# COUNTY OF ALBEMARLE TRANSMITTAL TO THE BOARD OF SUPERVISORS

AGENDA TITLE: ZMA202400004 Flow Steep Slopes	AGENDA DATE:
Amendment	May 7, 2025
SUBJECT/PROPOSAL/REQUEST:	<b>STAFF CONTACT(S):</b>
Rezone Preserved to Managed Steep Slopes;	Filardo, Herrick, Barnes, McDermott,
Remove existing proffers (ZMA201600023)	Ragsdale
SCHOOL DISTRICT: Stone Robinson Elementary School, Burley Middle School, and Monticello High School	<b>PRESENTER (S):</b> Rebecca Ragsdale, Planning Manager

Figure 1: Concept dated October 22, 2024 2025

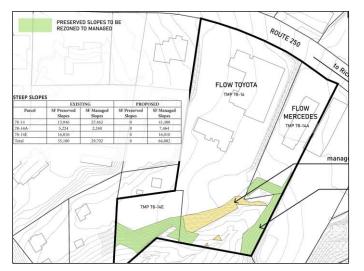
Staff recommended denial of the request reviewed at the PC public hearing (Figure 1) because it included the entirety of all Preserved Slopes on parcels 0780000001400, 07800000014A0, and 078000000014E0. However, both staff and the PC acknowledged portions of Preserved Slopes on 078000000014A0 are around a previously approved and constructed stormwater basin and could potentially support a more limited request that included less area. Additionally, staff believed that the proposal should provide mitigation to offset the loss of slopes and the 2.47-acre preservation area, provide hillside clean-up and stabilization, and include adequate area for plantings.

Following the PC meeting, a revised application and proffers were submitted. (Attachments D and E) The request is reduced and now limited to a 15,704 square foot area as shown on Attachment D and in Figure 2 below. Newly-submitted proffers now address the concern of the 2.47-acre preservation area previously proffered by providing on-site stormwater treatment for phosphorus reduction equal to twice the total phosphorus load reduction provided by 2.47 acres of forest land cover on the property. Replacement of the existing stormwater facilities with new enhanced stormwater facilities, agreement on a stream buffer area, and proposed stabilization on 07800000014E0 would improve the overall quality of this stream watershed.

Staff believes that prior concerns have been addressed and recommends that the Board adopt the attached Ordinance (Attachment F) to approve the rezoning from Preserved to Managed Slopes subject to the newly-submitted proffers (Attachment E).
